SSD-86270706 - 5 Blue Street, North Sydney – Submission

This submission has been prepared on behalf of the Trustees of the Roman Catholic Church for the Archdiocese of Sydney (**CAS**) in relation to the proposed Housing Delivery Authority (**HDA**) State Significant Development (**SSD**) application at 5 Blue Street, North Sydney (SSD-86270706).

The proposed development relates to the adaptive reuse of the existing building known as the Zurich Building.

Figure 1 Boundary setback plan – existing development to the south
Source: Appendix F Architectural Design Report, fjc Studio

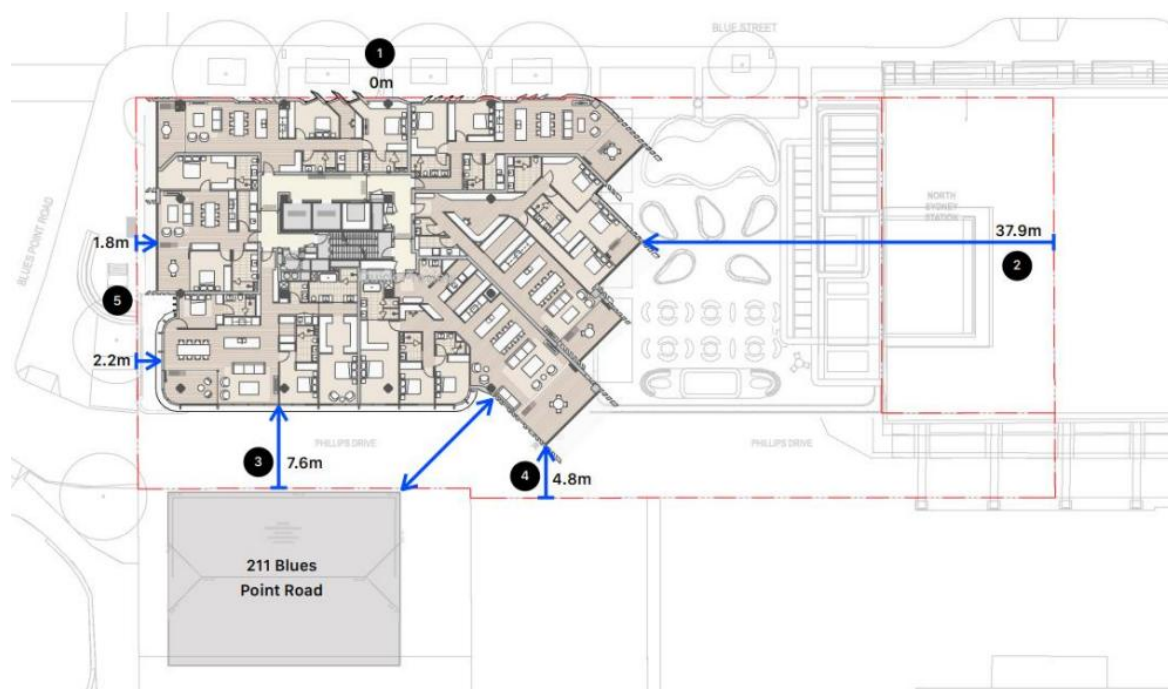
The scheme lodged under SSD-86270706 proposes non-compliant building separation distances to the south which does not achieve the visual privacy objectives of the Part 2F – Building Separation of the ADG. **Figure 1** below indicates the setbacks proposed and the existing development at 211 Blues Point Road and **Figure 2** identifies the indicative built form of the SFX site.

These setbacks do not change across the upper levels of the building, where the proposal maintains a habitable setback of 7.6m and 4.8m to the boundary at the interface with the SFX site.

Whilst conflicting in approach, neither rationale addresses the core issue in that the proposal’s setbacks remain non-compliant regardless of any future redevelopment of the SFX site – which is acknowledged in the EIS.

If the future southern context is genuinely ‘unknown’ (despite this massing being provided as part of pre-lodgement consultation), an appropriate design response would be to adopt conservative, ADG-compliant setbacks or otherwise compliance with the objectives of the Part, without relying on hypothetical redevelopment scenarios to justify reduced separation. The demolition of the existing building at 211 Blues Point Road is similarly irrelevant to the application of ADG building separation requirements and does not provide a basis for dismissing privacy, amenity or view-sharing impacts. Importantly, the SFX scheme has been designed to achieve ADG compliant setbacks from the shared boundary as follows:

- does not achieve the minimum ADG building separation,

- orients living rooms and balconies directly toward the SFX site, and
- provides no architectural or other justification in the EIS for these departures.

The reliance on the future demolition of 211 Blues Point Road does not resolve or explain the proposal's non-compliant setbacks, nor does it demonstrate how residential amenity impacts have been appropriately mitigated. As a result, the EIS does not provide appropriate justification for the non-compliance with Part 2F of the ADG.
